**2 Laird Drive - Zoning By-law Amendment Application
Request for Direction Report**

Date:	August 20, 2013
To:	North York Community Council
From:	Director, Community Planning, North York District
Wards:	Ward 26 – Don Valley West
Reference Number:	12 126026 NNY 26 OZ

Attachment 3: East and West Elevations

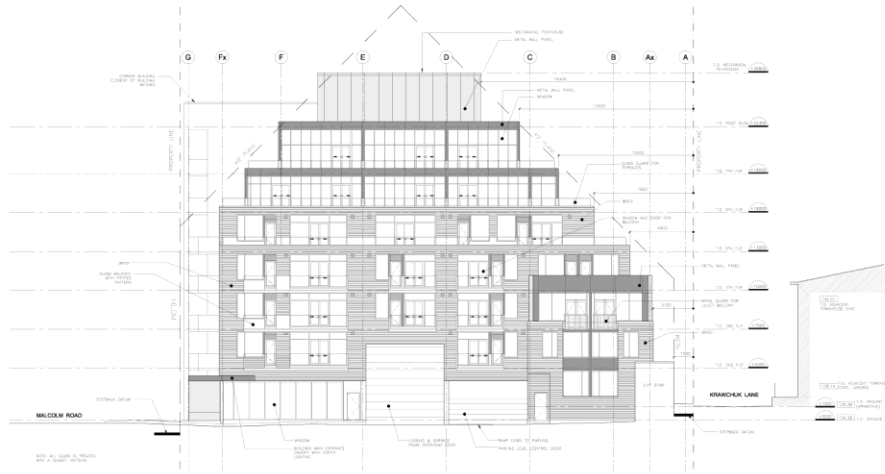
of the building is setback 6 metres from the lane to create a 14 metre separation zone. The floors above the townhouse base would step back 3 metres at each level and fall beneath a 45 degree angular plane measured from the main face of the proposed townhouses (refer to West Elevation on Attachment 3). Staff is recommending the building massing along the south side of the building facing Krawchuk Lane be revised so that the height of the building, or any portion thereof, does not exceed the horizontal distance separating the building or portion thereof measured from the front property line of the existing townhouses facing Krawchuk Lane (beginning at No. 1 Krawchuk Lane). This 45 degree transition would provide more appropriate access to day light and a visual privacy separation for the existing townhouses facing the lane. In view of the orientation of the existing 3-storey townhouse form buildings fronting Millwood Road, with no windows facing the lane and rear yard driveway/parking areas, staff can support the proposed building transition at this corner of the building along Millwood Road (refer to East Elevation on Attachment 3).

To the west, at 23 Malcolm Road, the single detached dwelling has windows looking onto the subject site. The west façade of the proposed building also has windows, balconies and terraces looking onto Krawchuk Lane. The lower portion of the proposed building (4-storeys) is setback 12.4 metres from the west property line and the windows on 23 Malcolm Road are set back 3 metres from the property line to create a separation distance over 15 metres. The upper floors (5 to 7) would step back 3 metres at each level and fall beneath a 45 degree angular plane measured from the west property line. The existing grade along the west property line slopes approximately 1.5 metres from the south (Krawchuk Lane) to the north (towards Malcolm Road). The proposed transition appears to be measured from the highest point of the property line. Staff is recommending the height of the building, or any portion thereof, not exceed the horizontal distance separating the building or portion thereof measured from a point taken from at the mid-point of the west property line (adjacent to the existing dwelling at 23 Malcolm Road).

- a) The Owner addressing the following design related matters to the satisfaction of the Director, Community Planning, North York District:
 - i) An appropriate transition be provided on the west and south sides of the building as outlined in the staff report;
